FCC ID: NEH-96000NB

Changes to Wulfshberg Electronics, Inc. Radio:

FCC DATA: RT9600

For Narrow Band Operation and

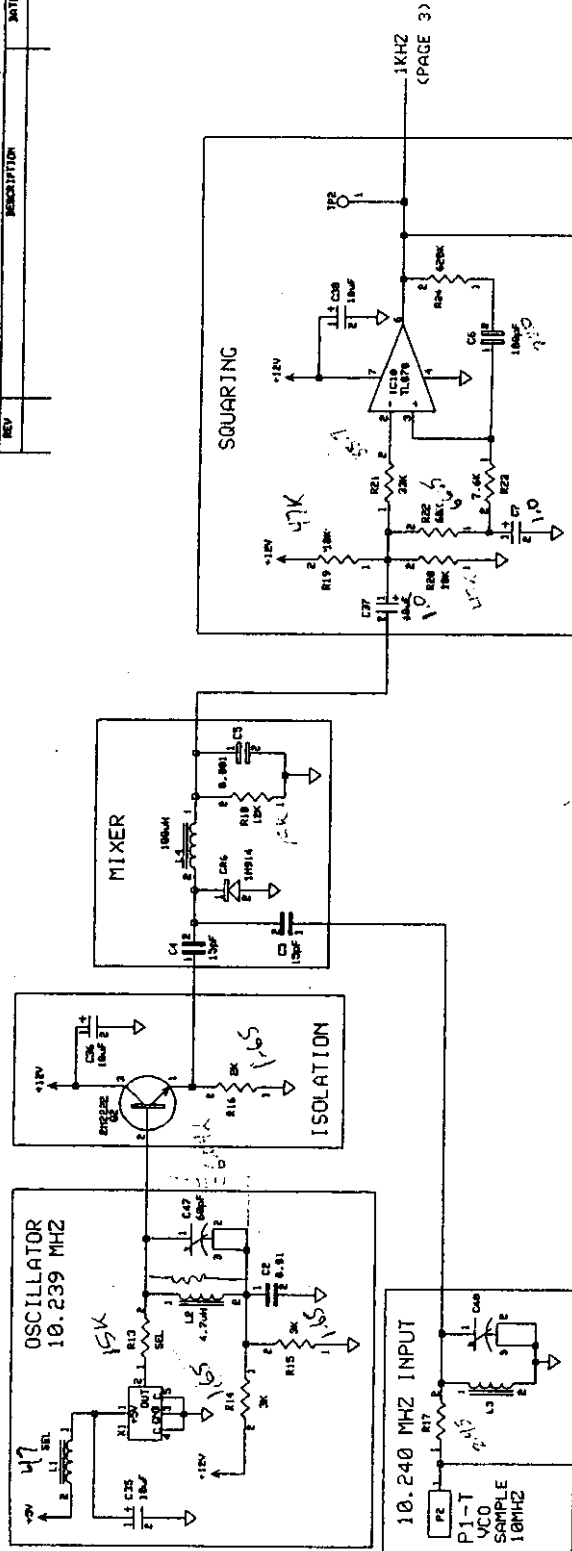
1. Replaced master oscillator with a TCXO made by Monitor Products, Inc., Oceanside, CA.
2. Changes one switch on front panel of the control head to change deviation limit level; i.e., (1) up position for narrow band deviation limit 1.5 kHz. Labeled "NB". (2) down position for wide band limit 3.0 kHz deviation. Labeled "WB".

1. Changed IF filter to narrow bandwidth for operation with a 12.5 kHz band spacing.
